MATERIAL INSPECTION REQUEST (MIR) FORM

Contractor:	HAIF COMPANY
Project:	QPMO-410-CT-00618- ROAD ACCESS TO RESORT CORE
Contract No.:	QI09043311-VO-0004
Material Inspection Request Number:	QRXM114000-HFC-TEC-MIR-ITS-02-RO5-00022

Project Name: Package 3 - **Interim Road Access to Resort Core**	**Project Code:** QRXM114000
Location: 00	**Date:** 31-March-2026
Document Title:**Material Approval Request FOR ITS SYSTEM SUPPLYING & INSTALLING BY TRAFFIC TECH SECURITY W.L.L** (Traffic Signal Head)	**Ref No:** QRXM114000-HFC-TEC-MAT-ITS-02-RO5-00014
	Rev No: 03

Drawing title: SHOPDRAWING OF TRAFFIC SIGNAL SYSTEM FOR JUNCTION-3

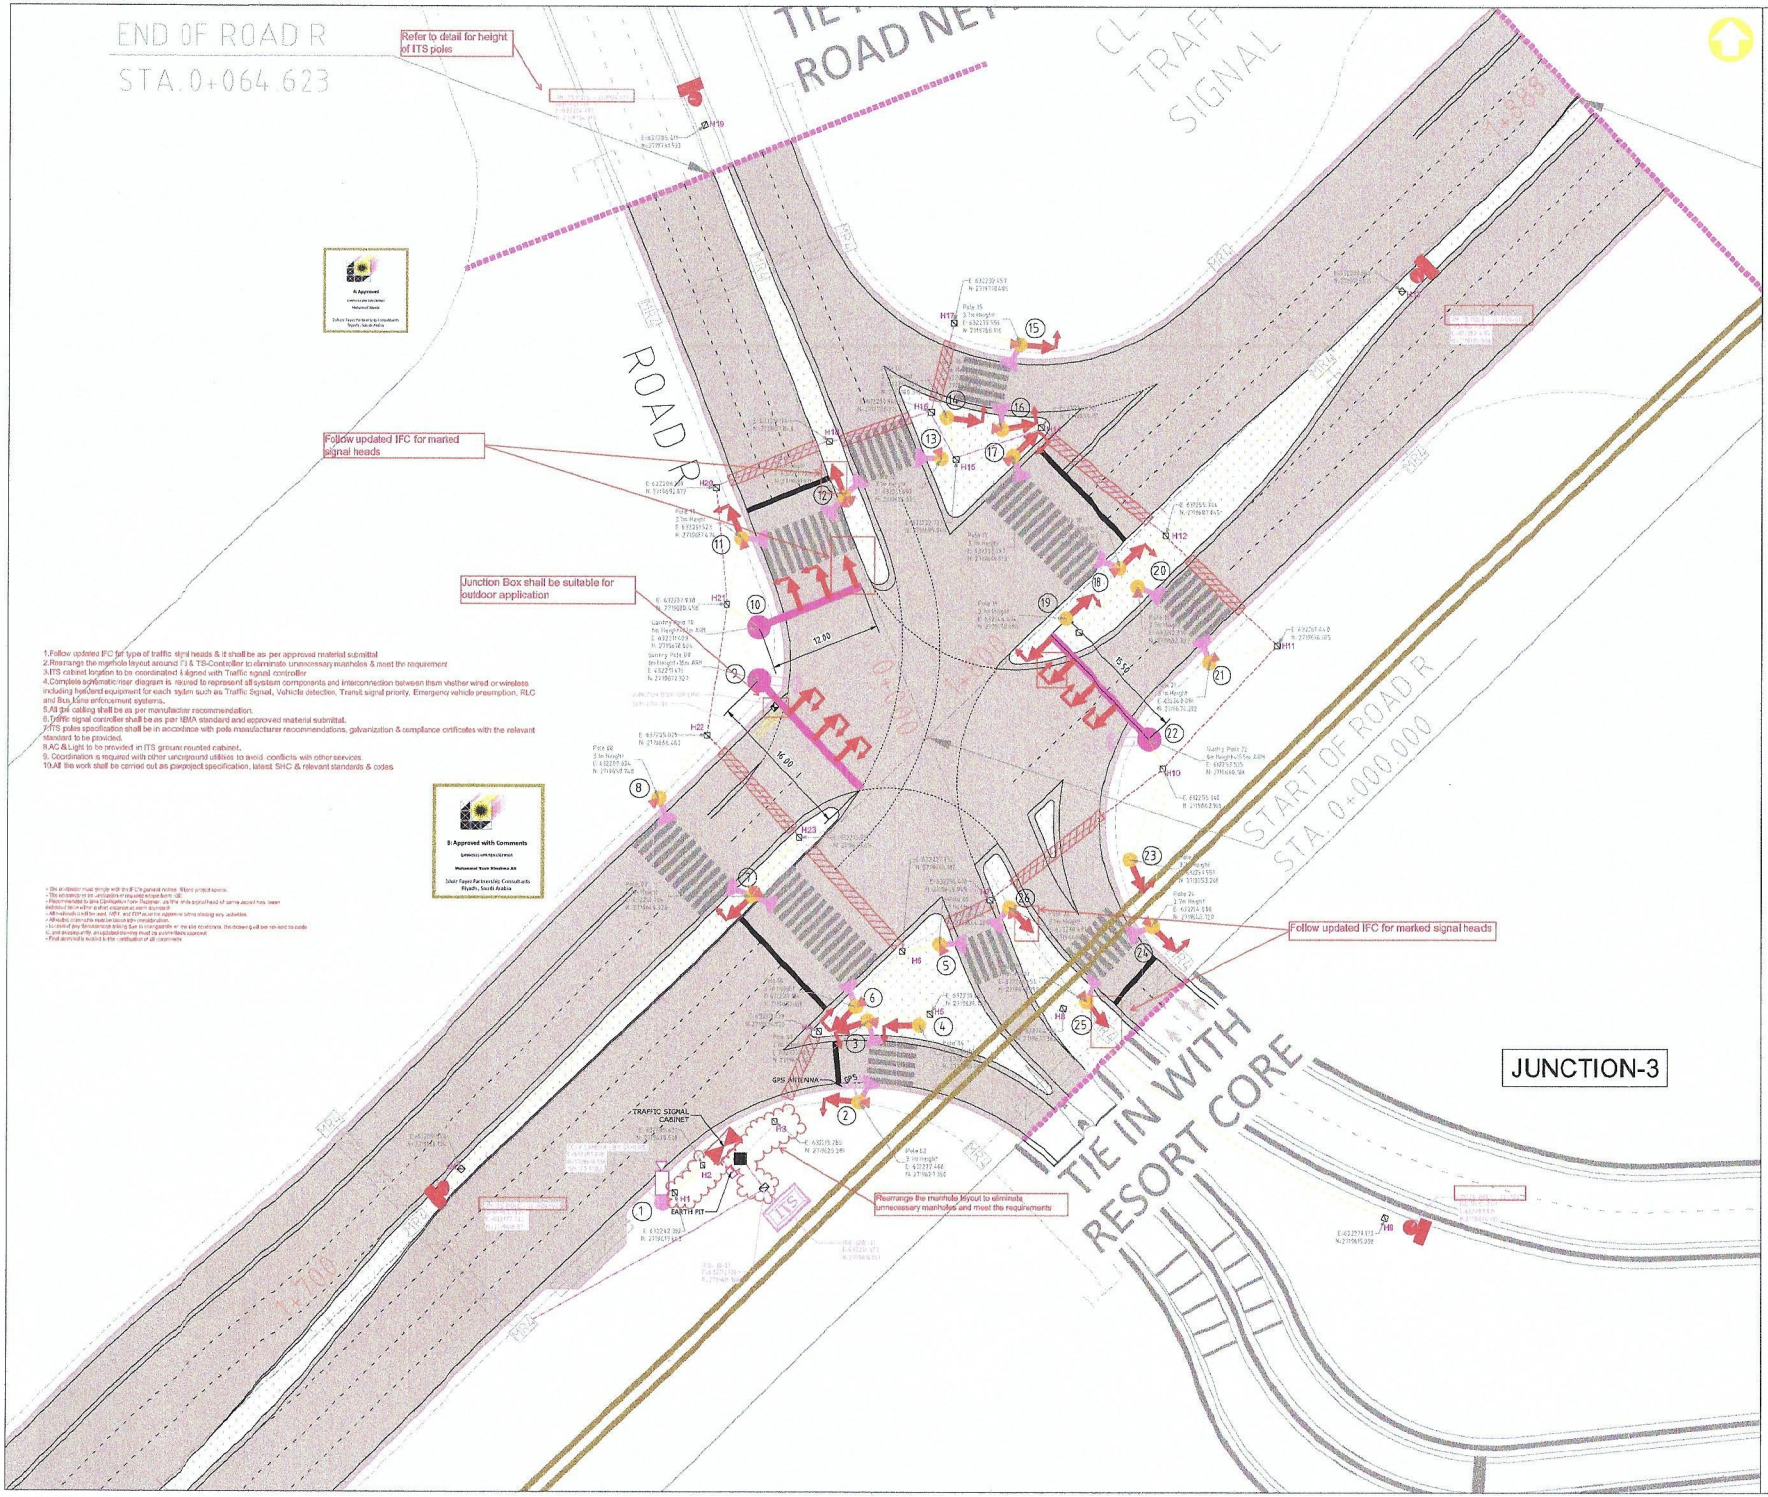
Noted the junction box LPR is suitable for outdoor application

Duct Banks & Manholes need to be in line

Rearrange the manhole layout to eliminate unnecessary manholes and meet the requirements

1.Rearrange the manhole layout around ITS & TS-Controller to eliminate unnecessary manholes & meet the requirements
2.ITS cabinet location to be coordinated & aligned with Traffic signal controller
3.Complete schematic/wiring diagram is required to represent all system components and interconnection between them whether wired or wireless including feasible equipment for each system such as Traffic Signal, Vehicle detector, Transit signal priority, Emergency vehicle preemption, RLC and Bus Lane enforcement systems.
4.All the cabling shall be as per manufacturer recommendation.
5. Coordination is required with other underground utilities to avoid conflicts with other services.
6.All the work shall be carried out as per project specification, latest SHC & relevant standards & codes

* All general comments noted on drawing and previous Rev. shall considered

1. ITS Cabinet location is already fed on site and coordinated with the traffic signal controller as per approved shop drawings.
2. the junction box LPR is suitable for outdoor application

ITS CABINET LOCATION IS ALREADY FIXED ON SITE AND COORDINATED WITH THE TRAFFIC SIGNAL CONTROLLER AS PER APPROVED SHOP DRAWINGS.
